Cleveland ES Intrusion Alarm Replacement

ADDENDUM #1

THS REF. # : FP2017-020 AD#1

ADMINISTRATION &
MP SIGNAL FLOOR
PLANS

E3.3.1

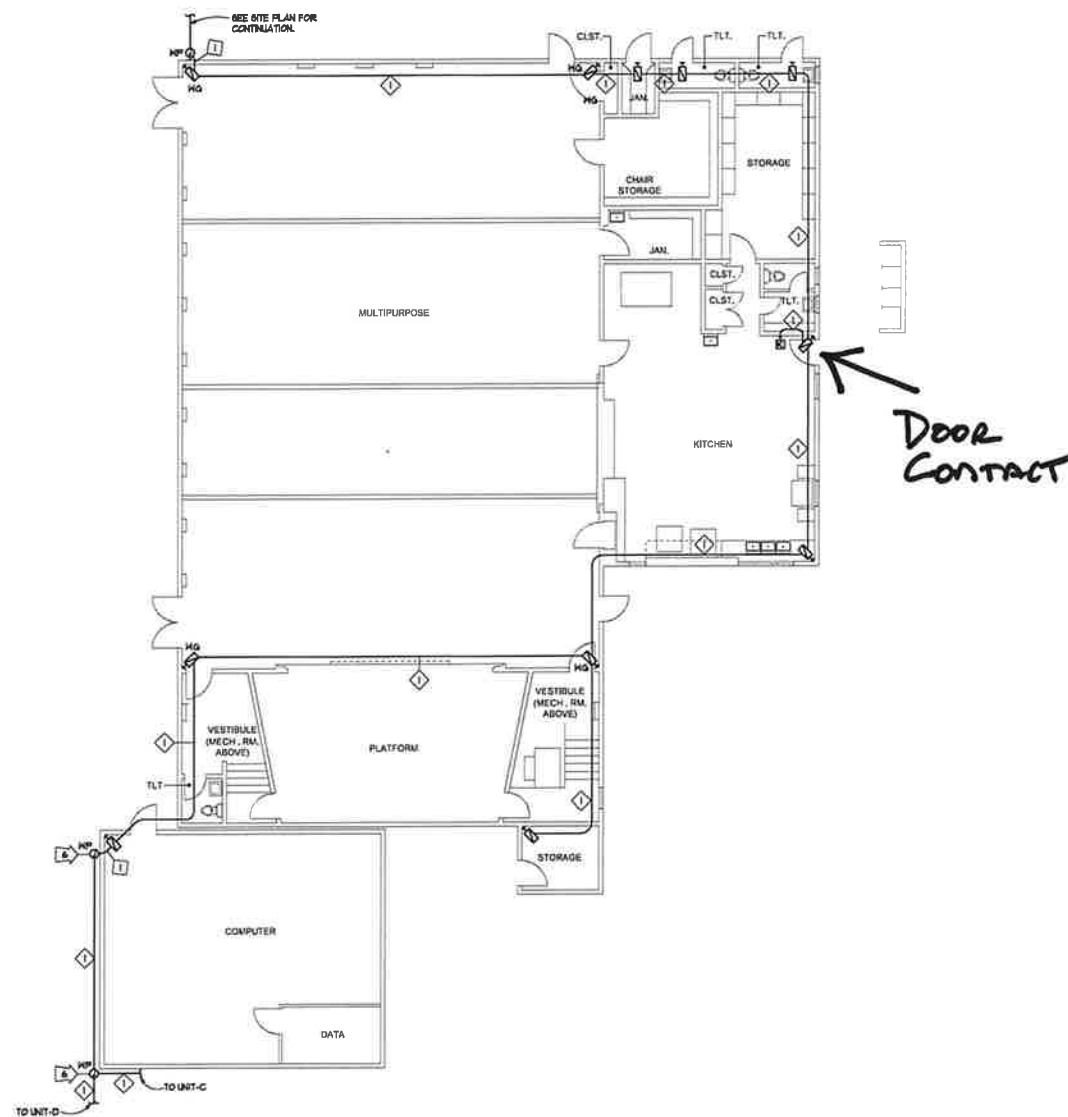
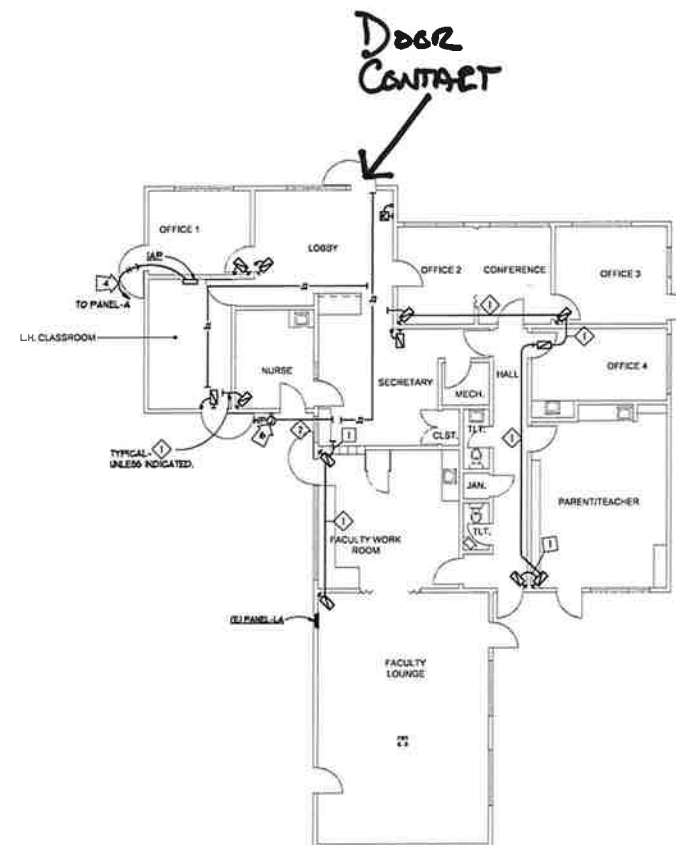
Item 1. Door Contacts – Door Contacts will be located on exterior doors in the area of the key pad. 1. The main entry at the Administration Building. 2. The back door at the kitchen next to keypad. See E3.3.1 attached
